LINCOLN CITY/LANCASTER COUNTY PLANNING STAFF REPORT

for October 26, 2016 PLANNING COMMISSION MEETING

- PROJECT #:** Special Permit No. 16047
- PROPOSAL:** A request per Section 27.63.170 for parking in residential zoning districts.
- LOCATION:** Generally located between A Street and Washington Street at 2847 A Street
- LAND AREA:** Approximately 1.57 acres
- EXISTING ZONING:** B-3 Commercial (to be rezoned to R-6 Residential), R-6 Residential, R-2 Residential
- CONCLUSION:** The parking lot should have minimal impact on the surrounding area with appropriate screening and will provide more off street parking for the Zoo. The reduction to the front yard setback is acceptable with the addition of street trees to mitigate the loss of green space versus Washington/S. 29th Street.

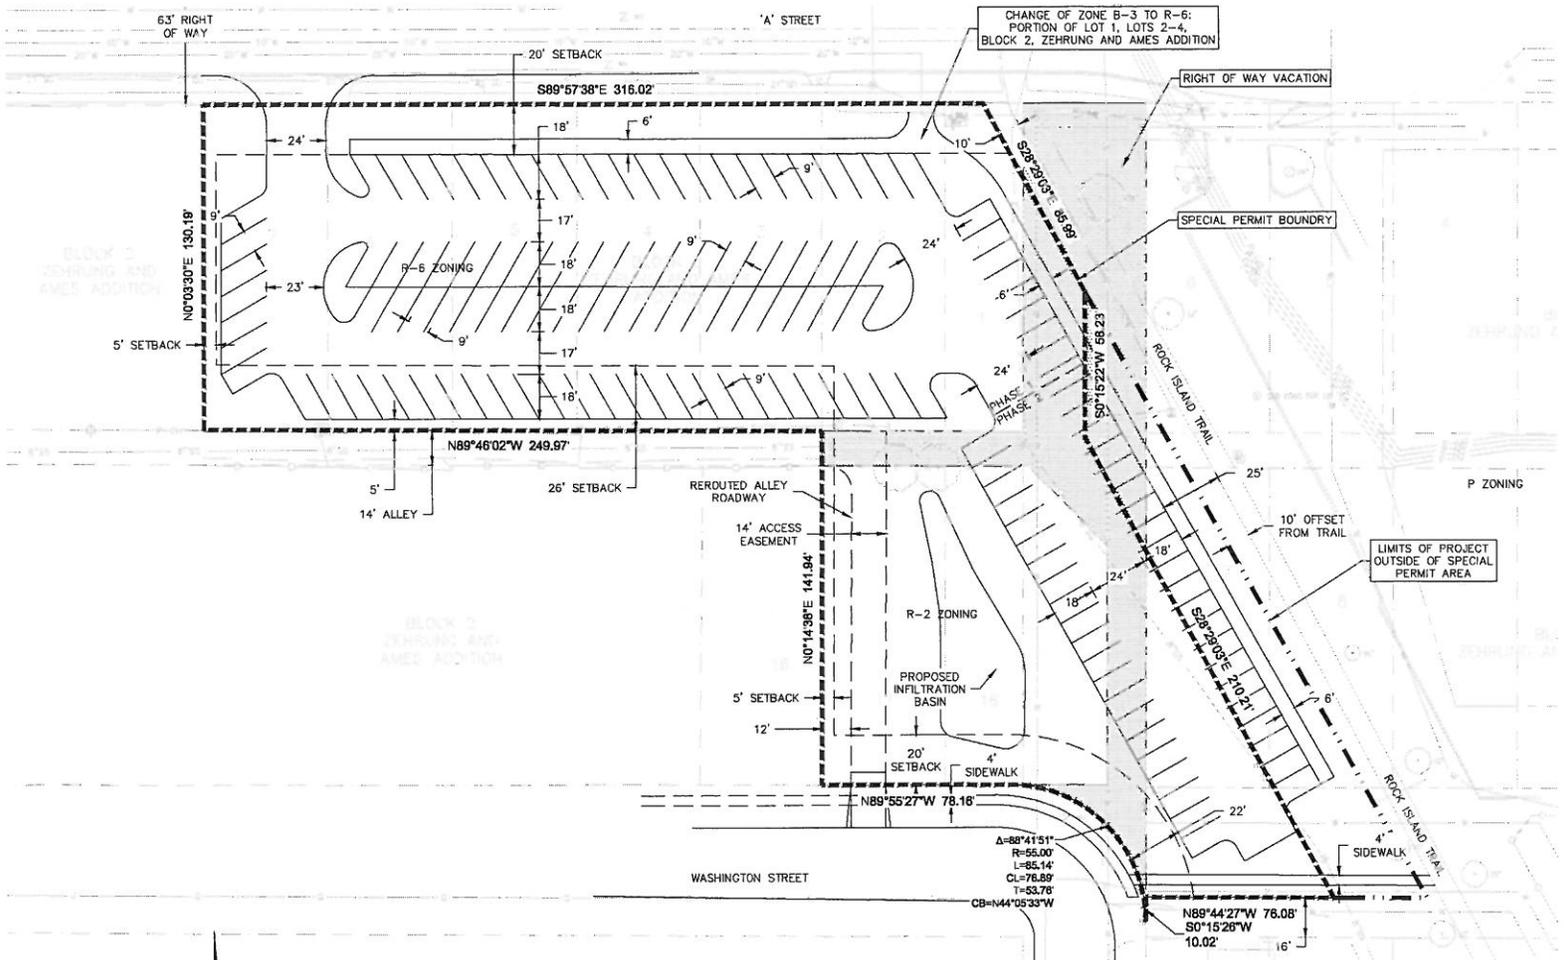
UTILITIES: The area is served by existing utilities. The proposed replacement infiltration basin is located over a 24" water main. Adjustments will be needed to address cover depth over the 24" water main. There is a sanitary sewer located under the parking lot. Easements need to be retained and access to manholes considered in the design. Also, LES will need retention of all easements due to existing facilities.

- 1.1 Identify that the only two existing trees shown on the grading plan, within the boundary of the special permit, are to be preserved.
- 1.2 Revise Note #1 to state "Parking lot layout is conceptual. Any revisions to the layout will be done by administrative amendment."

- 1.3 Revise Note #3 to state that a separate waiver was requested to the City of Lincoln Parking Lot Design Standards to allow Phase 2 of the Parking Lot to be surfaced with gravel/aggregate for a period of time not to exceed two (2) years.

- 1.4 Change Note #4 to state The Proposed 14' Access Easement on Block 2, Lot 17 will be surfaced with aggregate and will receive a concrete driveway approach from 5' north of the property line to the back of curb on Washington Street.

- 1.5 Change Note #9 to A landscape screen of at least 60% from ground elevation to a height of 10 feet will be provided along the west side of Lot 17, Zehrunge and Ames Addition.

- 1.6 Add note at Washington Street and S. 29th Street that measures will be taken to safely mark the new curve in the gravel street to the satisfaction of the Public Works & Utilities Department.

- 1.9 Submit Plan with corrections to the satisfaction of the Public Works & Utilities - Water Division concerning Replacement Infiltration Basin over 24" water main.

- 1.10 Submit Plan with corrections to the satisfaction of the Public Works & Utilities - Wastewater Division concerning sanitary sewer. Easements need to be retained and access to manholes considered in the design for existing sanitary sewer that is located under the parking lot.
